# Access Compliance Report

## Public Rights-of-Way

### (Curb Ramps)

Intersection ID: 28511	Main Street: BRAY_DR	Cross Street: HOLLY_PARK_DR	Location: E
ADA ID: 71409DA03616	Ramp Type: PerpDiag	Initial Pass/Fail: Fail	Overall Compliance: No
			Severity Score: 46.25

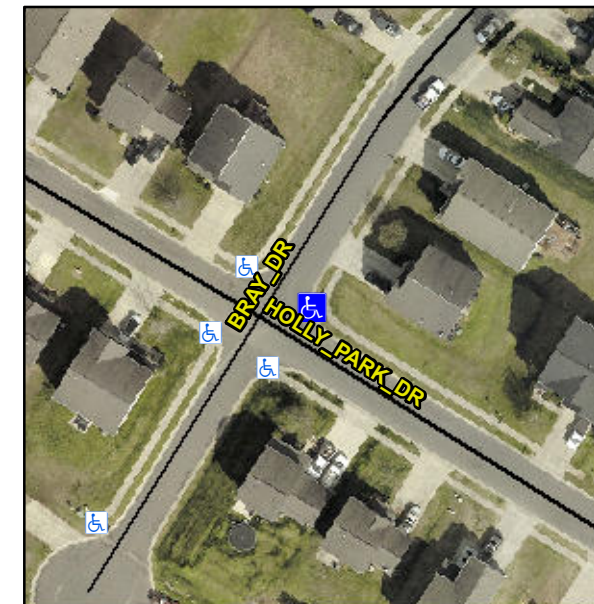
**Not Found, R304.5.1, R304.2.2, R304.5.3**

Compliance	Description	Data	Compliance	Description	Data
N/A	Ramp Length (in)	46.5	No	Ramp Slope (%)	9.3
No	Ramp Width (in)	36.5	No	Ramp XSlope (%)	15.0
N/A	Flare Type LT	N/A	N/A	Flare Type RT	N/A
N/A	Flare Slope LT (%)	N/A	N/A	Flare Slope RT (%)	N/A
N/A	Flare Traversable LT?	N/A	N/A	Flare Traversable RT?	N/A
N/A	Landing Length (in)	N/A	N/A	DWS Provided?	N/A
N/A	Landing Width (in)	N/A	N/A	DWS Contrast?	N/A
N/A	Landing Slope (%)	N/A	N/A	DWS Length (in)	N/A
N/A	Landing X Slope (%)	N/A	N/A	DWS Full Width?	N/A
N/A	Landing Curb? (Y/N)	N/A	N/A	DWS Offset (in)	N/A
N/A	Shared Landing?	N/A			
N/A	Gutter Ponding?	N/A	N/A	Gutter Slope (%)	N/A
N/A	Gutter Lip Ht (in)	N/A	N/A	Gutter X Slope (%)	N/A
N/A	Painted X Walk1?	No	N/A	Painted X Walk2?	No
	X Walk 1 Direction	To NW		X Walk 2 Direction	To SW
N/A	X Walk 1 Width (in)	N/A	N/A	X Walk 2 Width (in)	N/A
	X Walk 1 Slope (%)	4.2		X Walk 2 Slope (%)	3.6
	X Walk 1 X Slope (%)	8.0		X Walk 2 X Slope (%)	7.5

**Remove & Replace Curb Ramp With Two New Directional Ramps or Equivalent.**
